FCC ID: O4O-CE3871

Family Declaration Letter

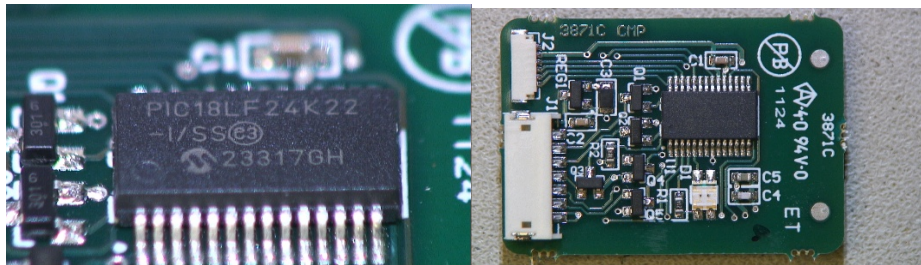
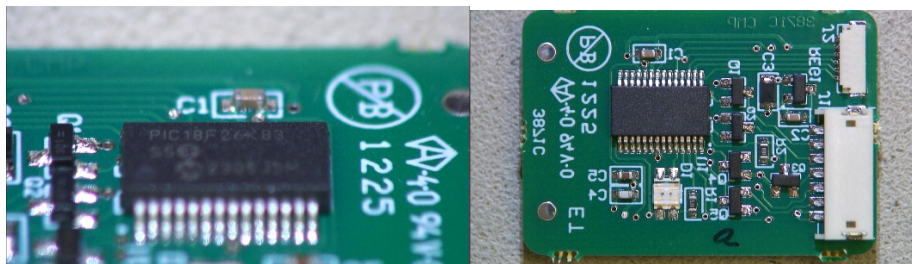
CE3871 has two different build models. The difference between the CE3871-0 and CE3871-1 models does not affect the RF behavior. CE3871-0 uses PIC18LF24K22 for its processor. CE3871-1 uses PIC18F26K83 for its processor. The CE3871-1 changes the processor and firmware on the green board to allow it to buffer some communication from the tool rather than forcing the tool to stop operation until communication completes.
